### **TURKEY POINT NUCLEAR GENERATING STATION UNIT 3 AND UNIT 4**

#### **IMPROVED TECHNICAL SPECIFICATIONS CONVERSION**

##### **ITS SECTION 3.2 POWER DISTRIBUTION LIMITS**

**Current Technical Specification (CTS) Markup  
and Discussion of Changes (DOCs)**

Figure B 3.2.1B-1 (page 1 of 1)  
K(Z) - Normalized  $F_Q(Z)$  as a Function of Core Height

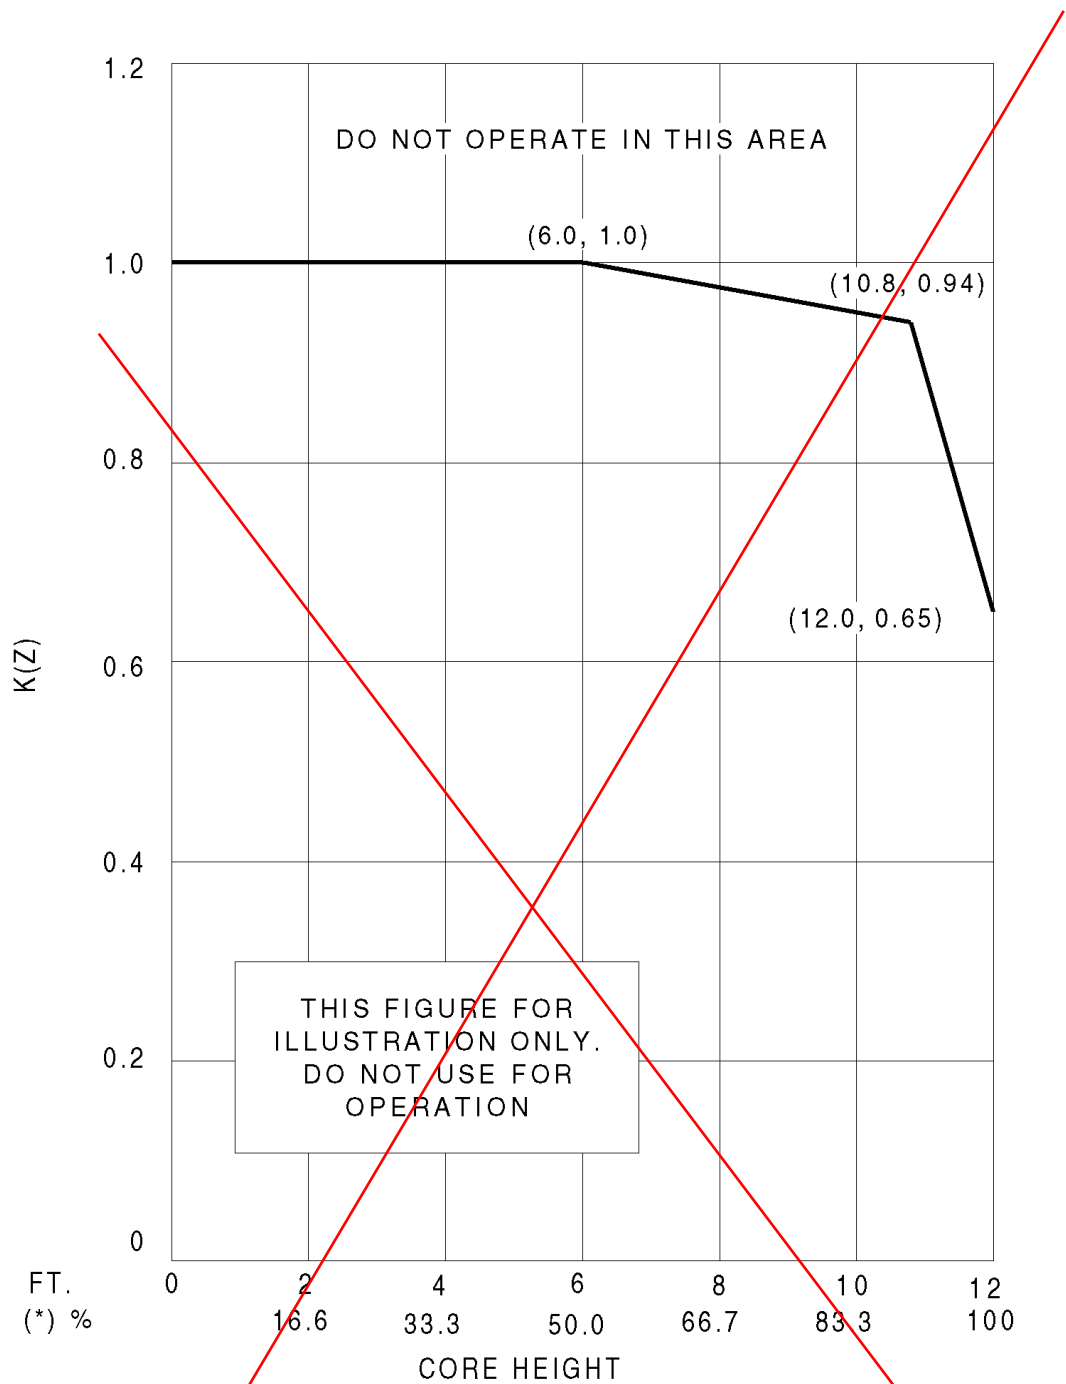
~~For this facility, the actual values of CFQ and  $K(Z)$  are given in the COLR; however, CFQ is normally a number on the order of [2.32], and  $K(Z)$  is a function that looks like the one provided in Figure B-3.2.1B-1.~~

5. ITS Bases 3.2.1 contains Figure B 3.2.1 B-1,  $K(Z)$  – *Normalized  $F_Q(Z)$  as a Function of Core Height*. The PTN CTS 3.2.1 Bases do not contain this figure, rather the figure is defined in the COLR. Therefore, this figure is not being retained in the PTN ITS 3.2.1 Bases.

Figure B 3.2.3B-1 (page 1 of 1)  
AXIAL FLUX DIFFERENCE Acceptable Operation Limits  
as a Function of RATED THERMAL POWER

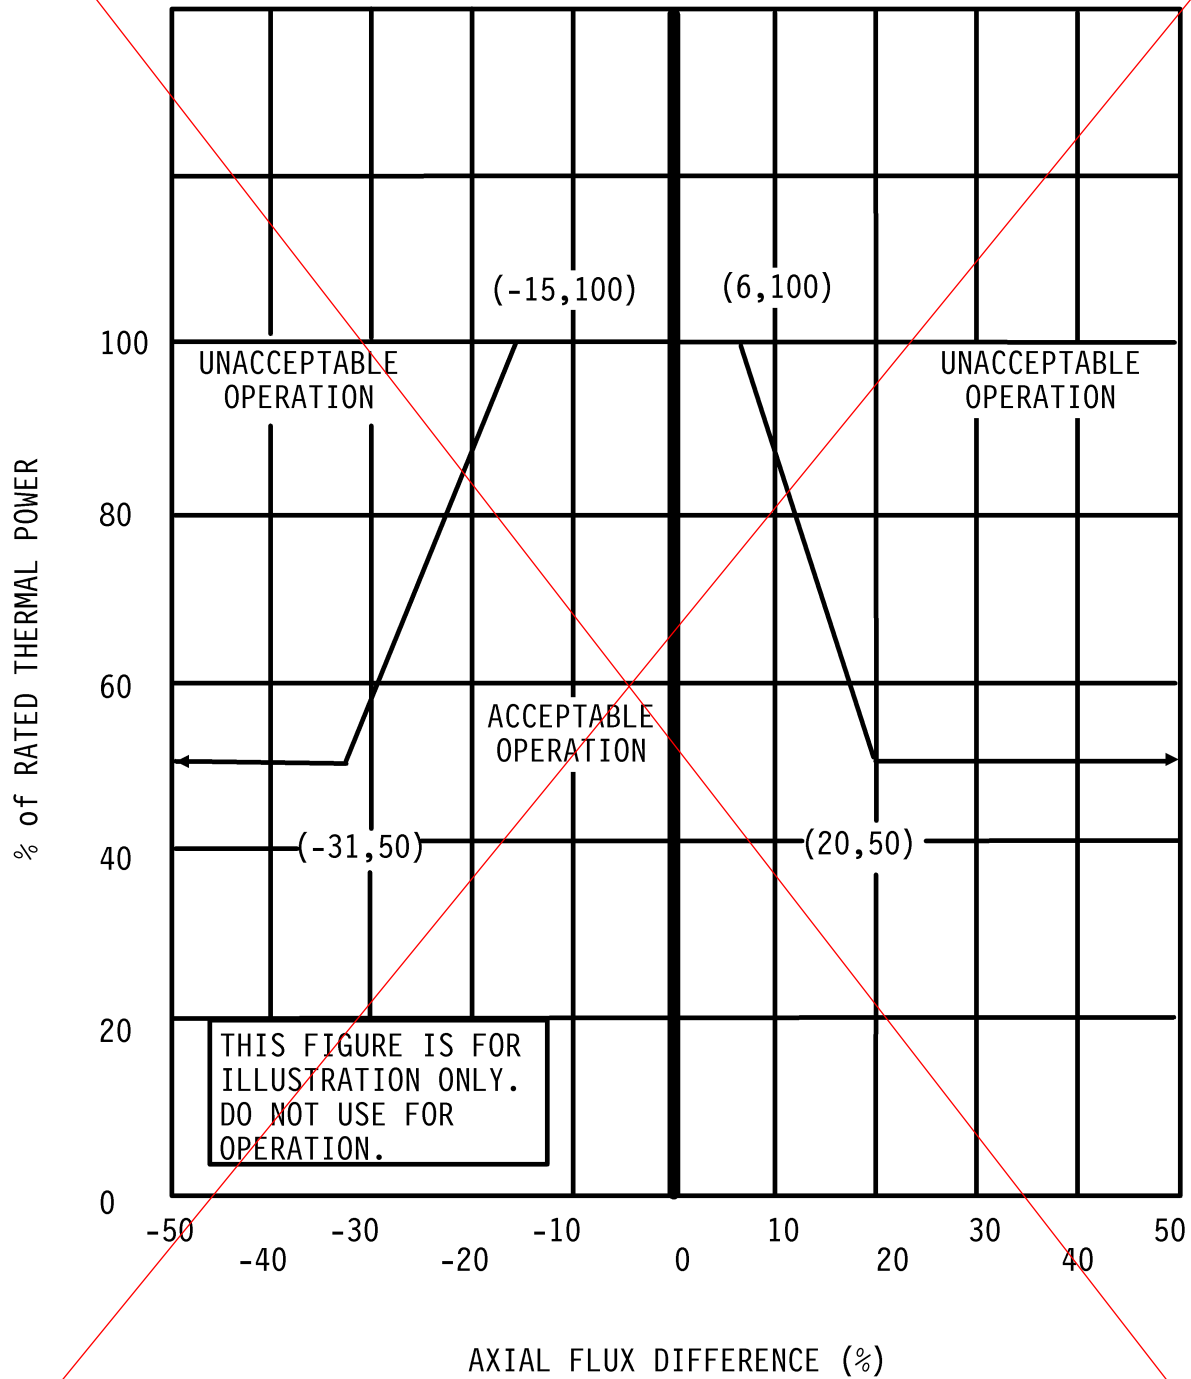
The AFD limits are provided in the COLR. ~~Figure B 3.2.3B-1 shows typical RAOC AFD limits. The AFD limits for RAOC do not depend on the target flux difference. However, the target flux difference may be used to minimize changes in the axial power distribution.~~

5. ISTS 3.2.3 Bases contains Figure B 3.2.3B-1. This Figure is located in the Turkey Point Nuclear Generating Station (PTN) Core Operating Limits Report (COLR). Therefore, this figure is not included in the Bases for ITS 3.2.3.
